STAFF REPORT

TO: Planning Commission
 FROM: Curtis Hindman, Interim Community Development Director
 DATE: 5/10/2023
 RE: Site Plan Approval– Village West, Lot 7, Current Zoning – GC
 Not located within an overlay district

CONCEPTUAL PLAN
FOR
LOT 7 - COMMERCIAL TRACT
LAND LOT 247 - 1ST DISTRICT
COWETA COUNTY, GA
SITE PLAN

SHEET
C3.1

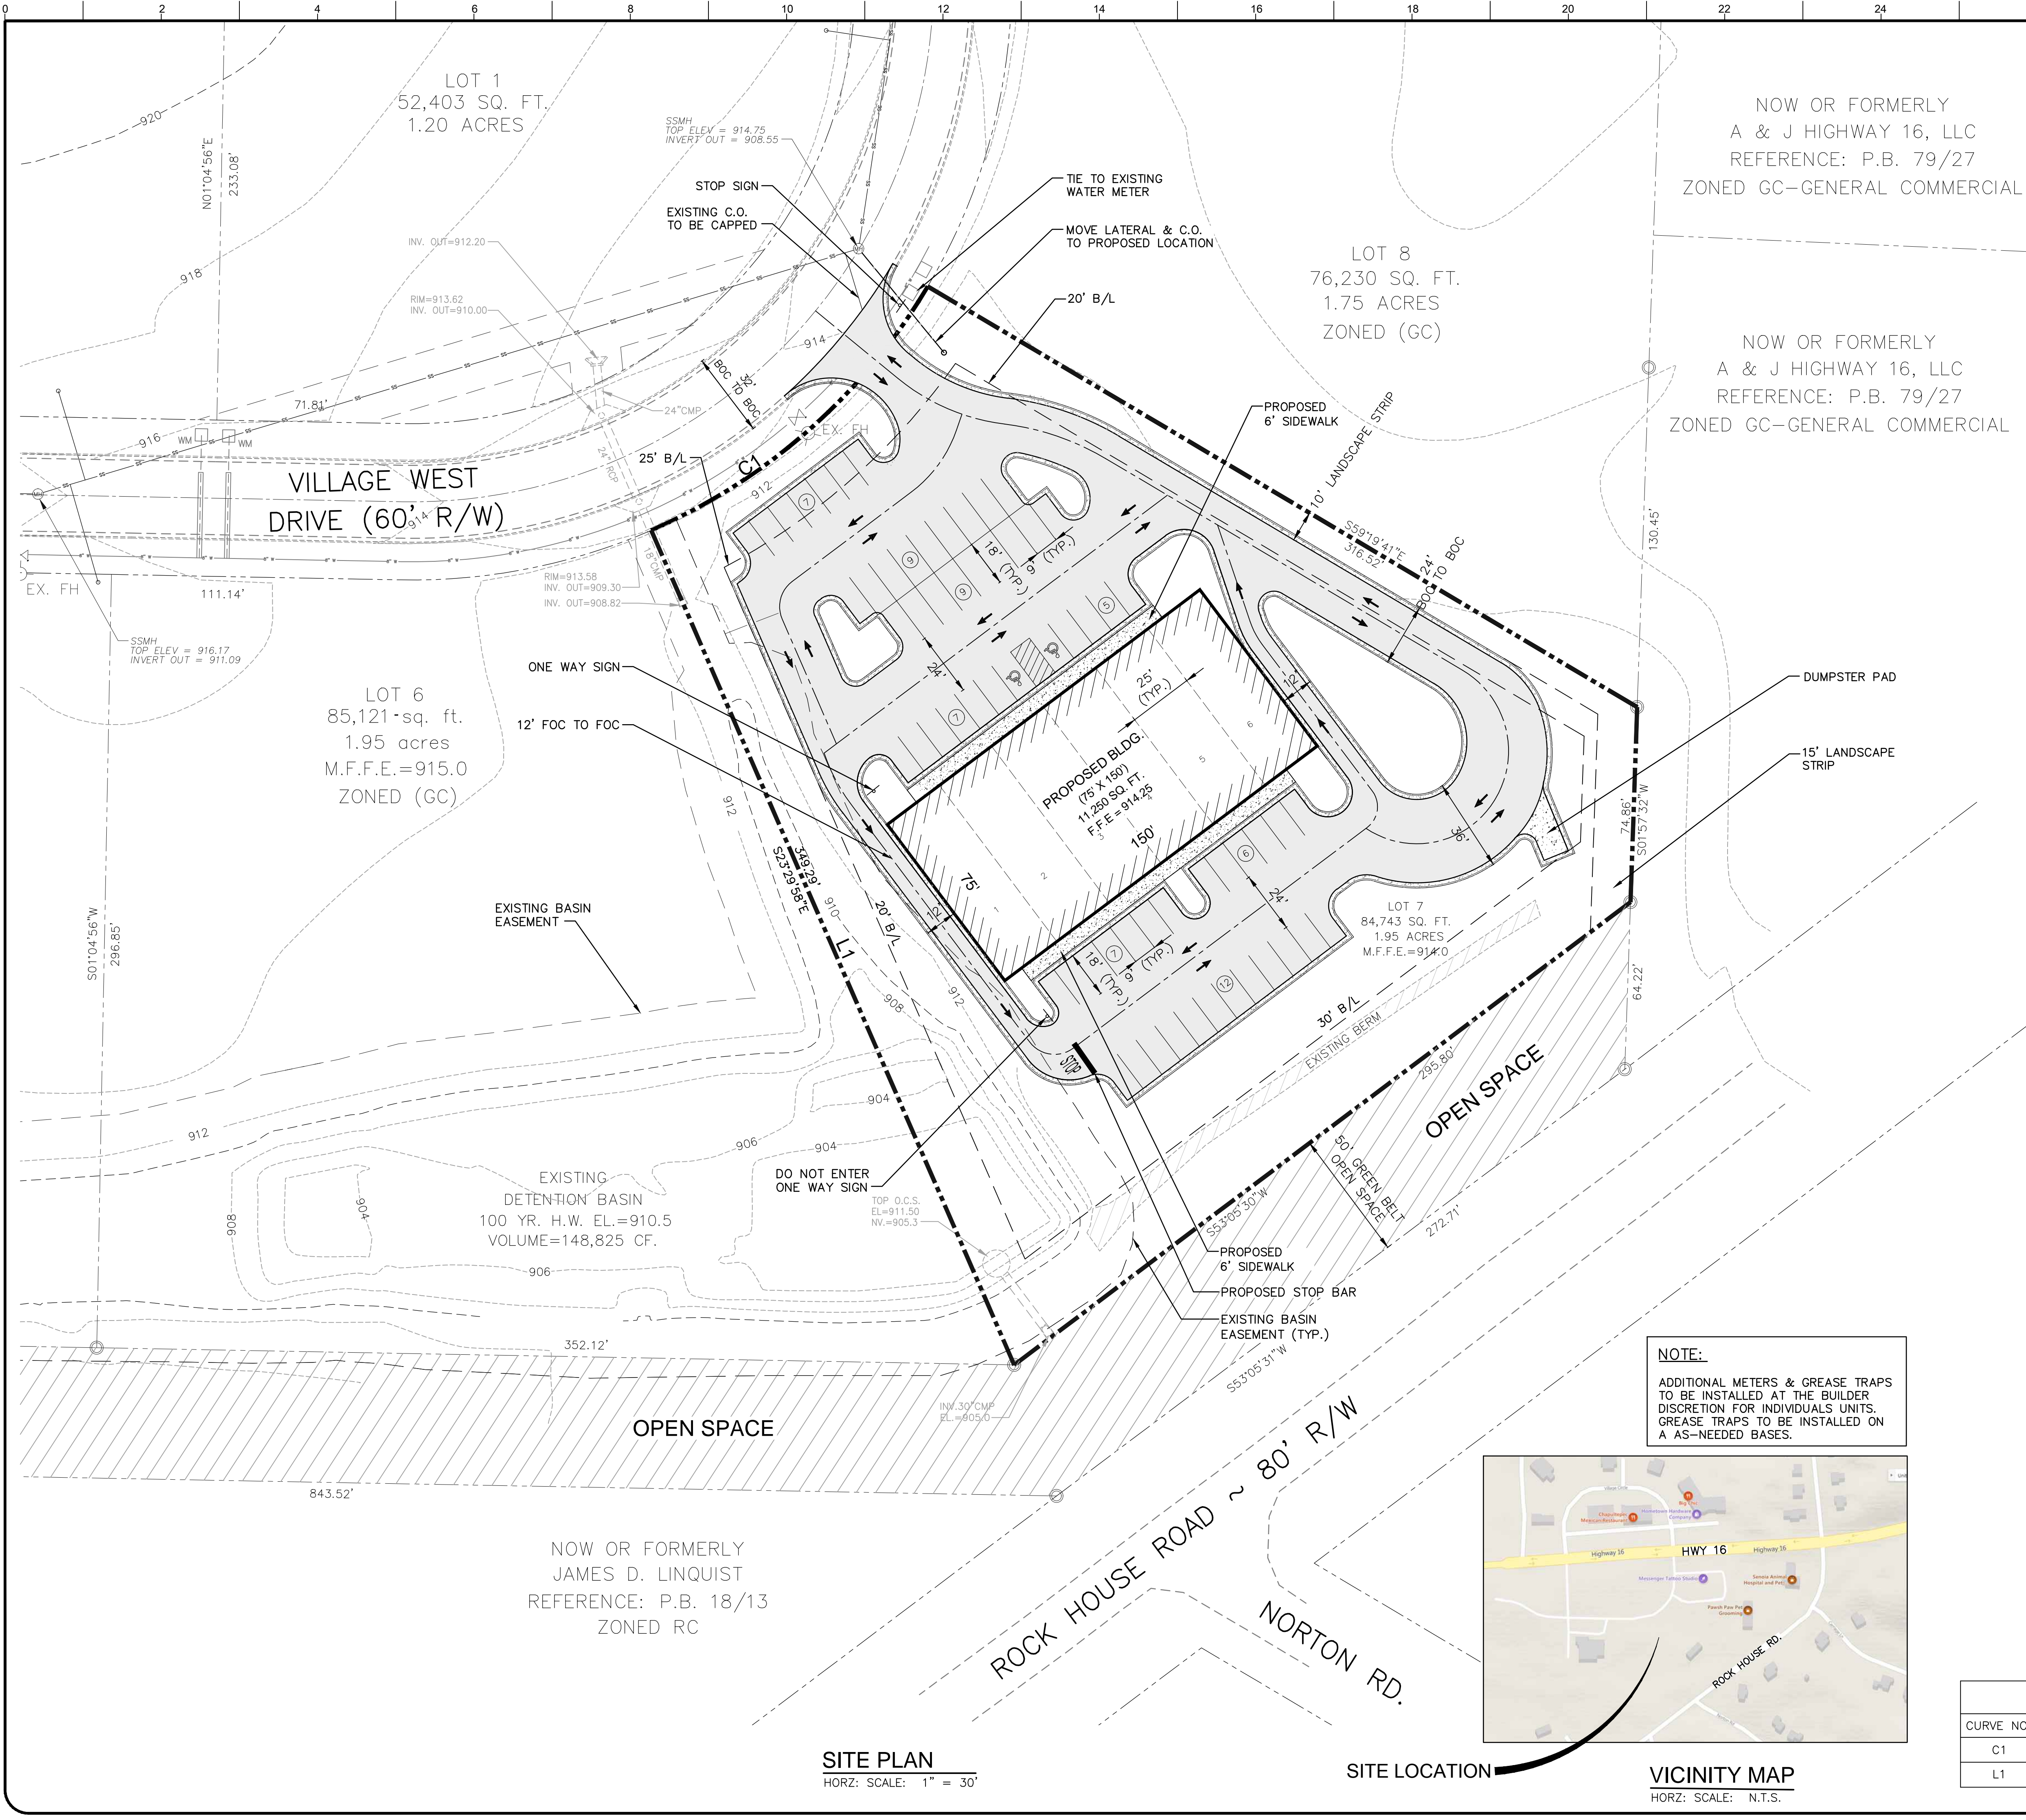
The zoning of the property to be developed and adjacent property.	yes	All GC
The location of greenbelts and other areas to be landscaped.	Yes	
Setback lines	yes	
Location and size of building.	yes	
Height of building.	no	TBD
Parking area and number of spaces required and obtained.	yes	Need to add 1 more H/C
Distance between buildings.	n/a	
Use of building.	Not provided	Drive thru shown
Location of sanitary sewage disposal if applicable.	yes	
LANDSCAPE PLAN REQUIREMENTS (CHAPTER 40, SECTION 40-229) A landscape plan is required for any development in Senoia other than the development of individual lots for single-family residential purposes:		
A landscape plan shall include one canopy tree with a minimum trunk caliper of two and one-half inches (at four inches from the ground) for every 1,000 square feet of permanently disturbed area on the site. An area is considered permanently disturbed if it is covered with a building, structure, or other impervious surfaces like walks, drives and patios.	No	Landscape plan not provided at this time.

Trees (d.b.h.) saved on this site plan:	None	No tree protection plan provided at this time.
